URGENT Field Safety Notice

Trilogy Evo, Trilogy Evo O2, Trilogy EV300
Flow Sensor Nebulized Aerosol Deposition

Reference: Flow Sensor Nebulized Aerosol Deposition
Trilogy Evo, Trilogy Evo O2, and Trilogy EV300
2024-CC-SRC-013

Figure 1: Acceptable In-Line Nebulizer Placement.

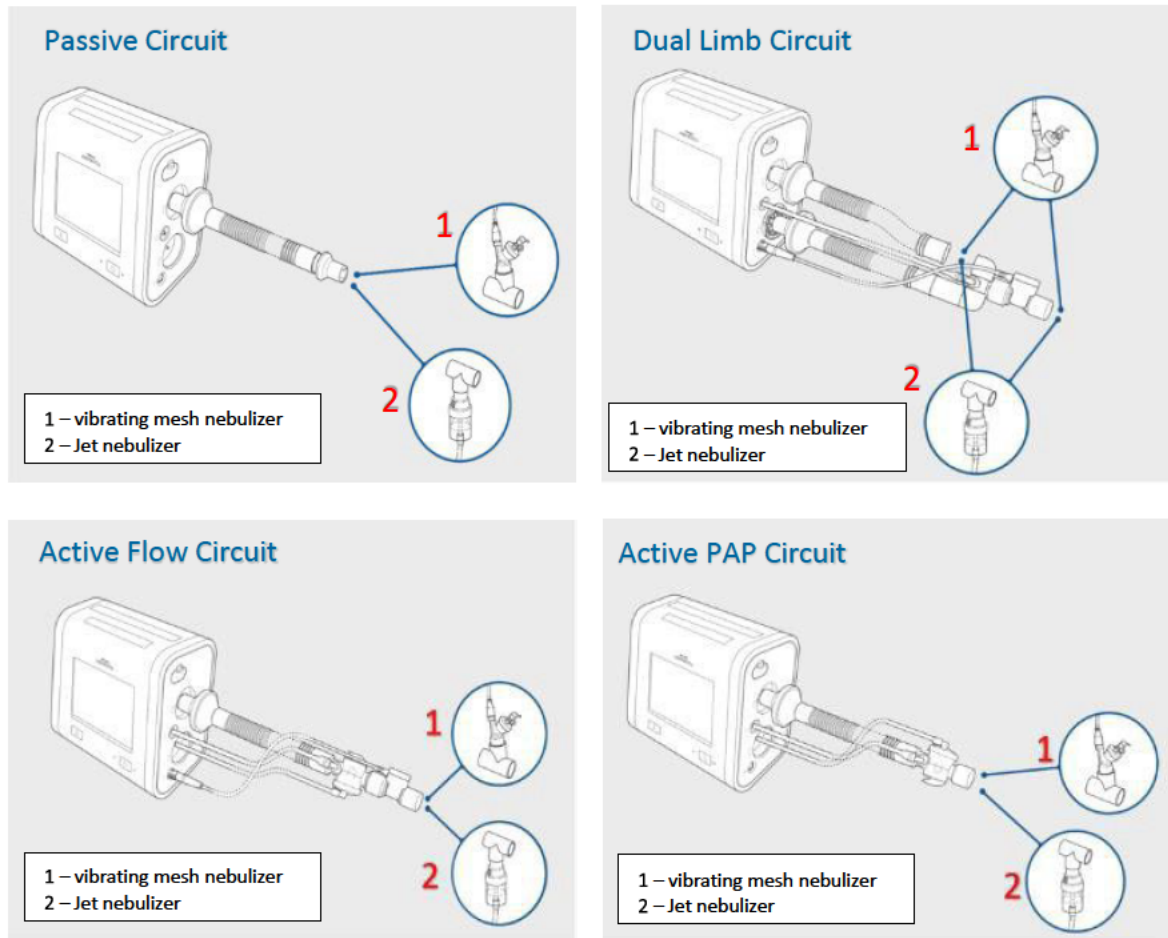
- If using in-line nebulizer treatments:
 - The circuit must be configured as pictured in the images in Figure 1 below
 - For prescriptions needing tidal volumes greater than 700 mL with a passive circuit, transition patient to alternate circuit (Active PAP, Active Flow, or Dual Limb).
